November 13, 2018

**RE: BARTLETT STREET EXTENSION
FILE #SE49-0810**

In response to Sarah Porter's September 7, 2018 memo on the above referenced file, we have revised the enclosed plans and hereby submit supplemental information. Our response to her 14 comments is as follows:

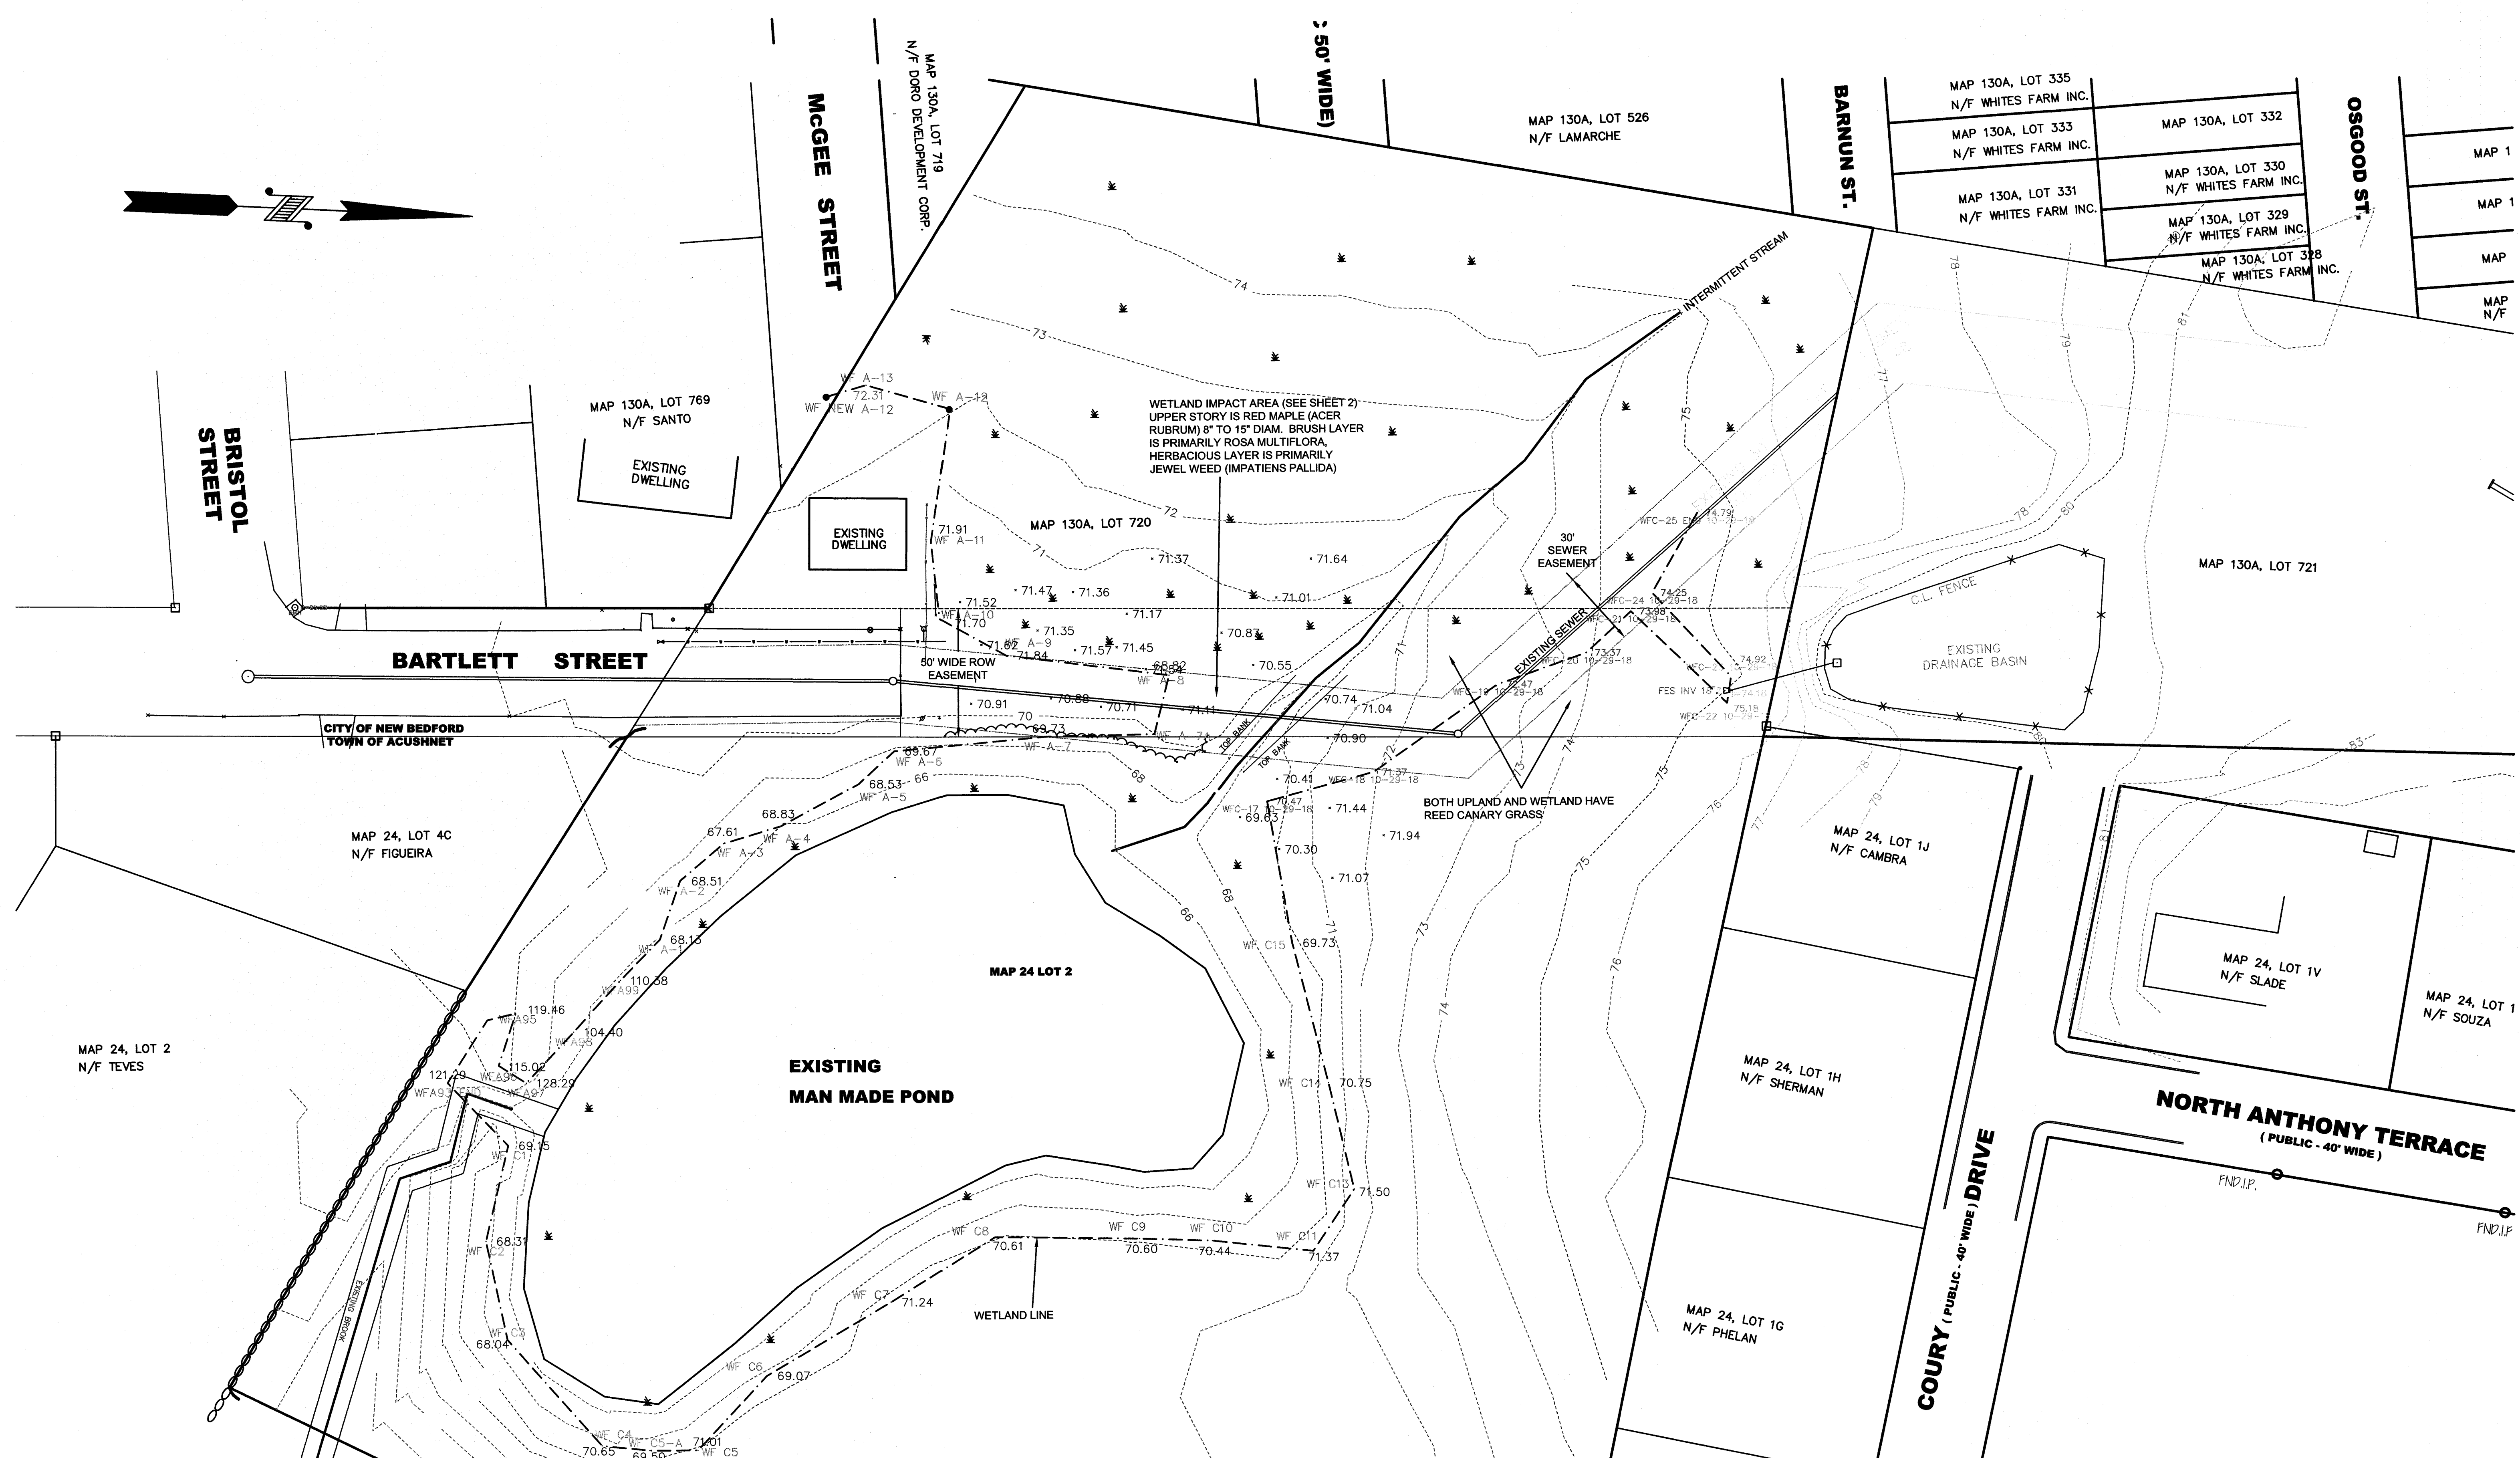
3. An Existing Conditions Plan (sheet 1) has been added to the enclosed plan set with all requested information.
4. An Erosion Control Plan has been added to the enclosed plan set as sheet 3.

7. The existing conditions for the wetlands being impacted are presented on the Existing Conditions Plan.
8. The wetland replication area has been revised, relocated and enlarged as requested.

Enclosed is a revised 3 sheet set of plans with revisions dated November 2, 2018. The eastern limit of the BVW has been flagged in the field and added to the plans. The replication area has been revised. Additional topographic detail has been added in that area. The length of the proposed drive has been shortened.

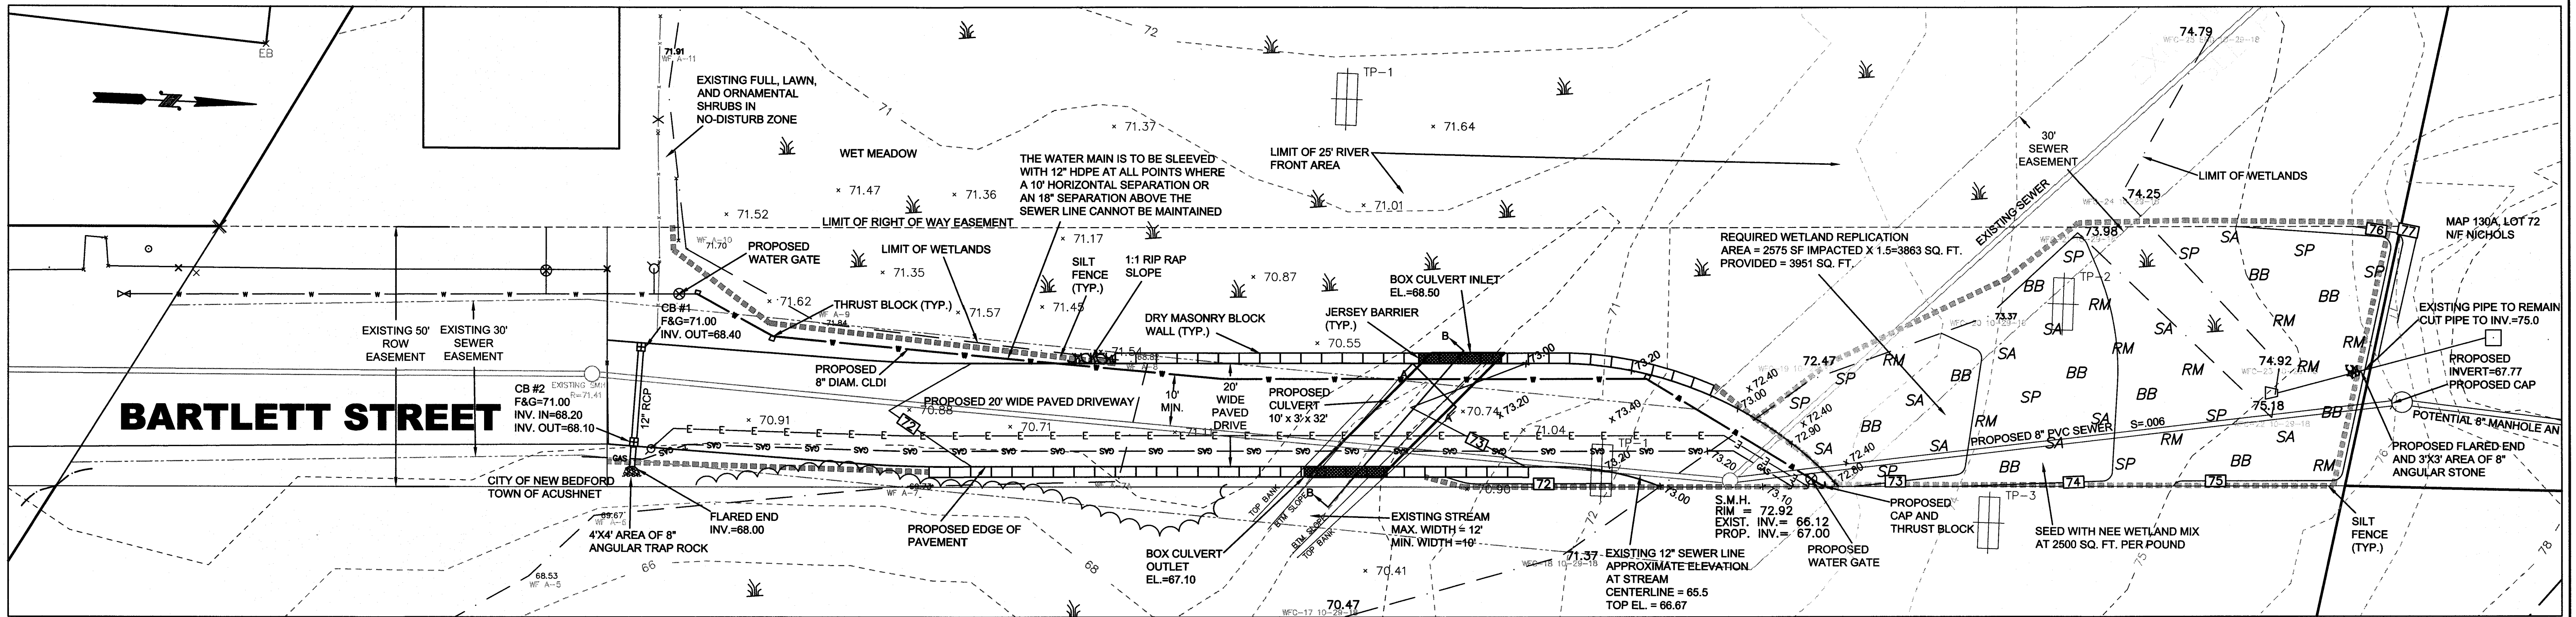
9. Enclosed are soil profiles of the wetland impact area and the wetland replication area.
10. The requested notes have been added to the plans.
11. We concur with getting a Wetland Specialist, who will monitor the replication area, to be approved by the Commission.
12. We concur that the replication soil be free of invasive rhizomes and plants. A note has been added to the plans.
13. An Invasive Species Management Program will be submitted to the Commission for approval prior to implementation of the wetland replication.
14. The requested sequence of construction for the utilities has been added to the plans (sheet 2).
